**IN RE: PALAU SUNSET HARBOR**

**SUPPLEMENTAL APPENDIX  
PETITION TO REVERSE DESIGN REVIEW BOARD DECISION**

**PETITION FOR REHEARING**

**Application Project Palau  
20<sup>th</sup> Street & Sunset Drive, Miami Beach**

**TOPOGRAPHIC SURVEY**

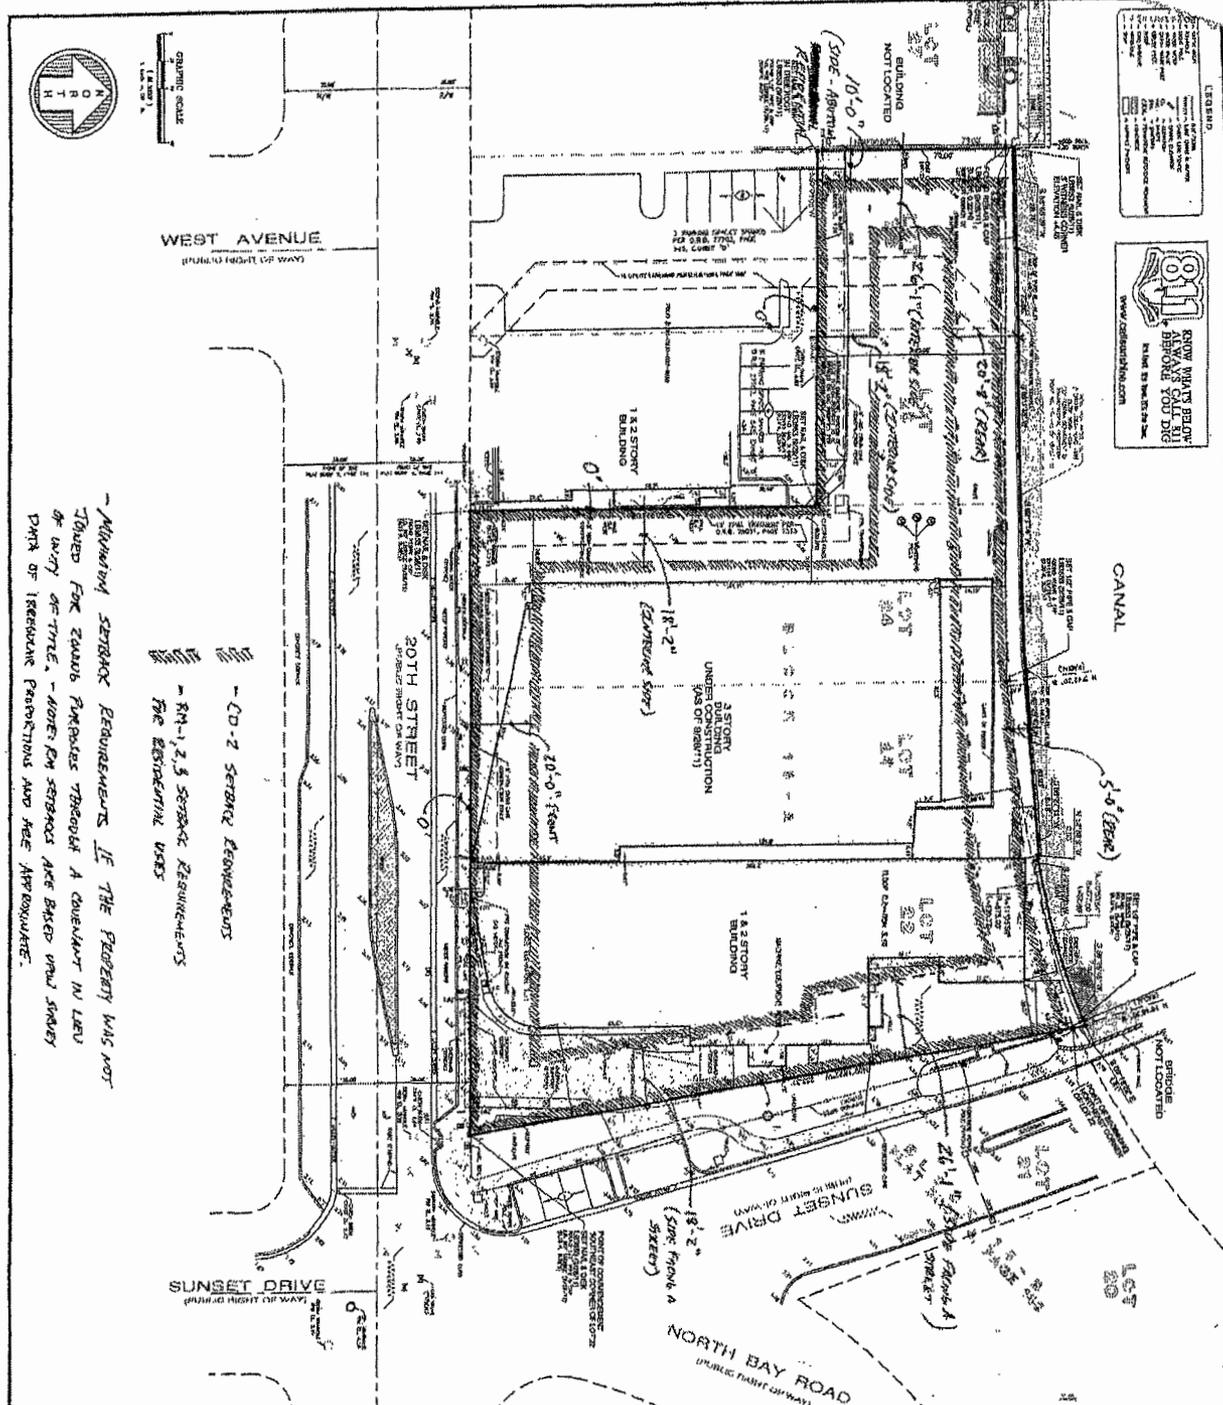
45. The City staff analyzed the setbacks immediately prior to the October 2, 2012 Design Review Board meeting and provided a copy of that analysis to MAC SH, LLC, a copy of which is attached hereto as Exhibit B.

48. The analysis shows that the modifications severely encroached on the setbacks that were respected in the 2004 approved site plan.

MANUAL SETBACK REQUIREMENTS IF THE PROPERTY WAS NOT  
 TRACED FOR CANALS PERMITS THROUGHOUT A QUARTER IN LINE  
 OF WAY OF TITLE. - NOTE: CANAL SETBACKS ARE BASED ON A STUDY  
 DATA OF IRRIGATION PATTERNS AND ARE APPROXIMATE.
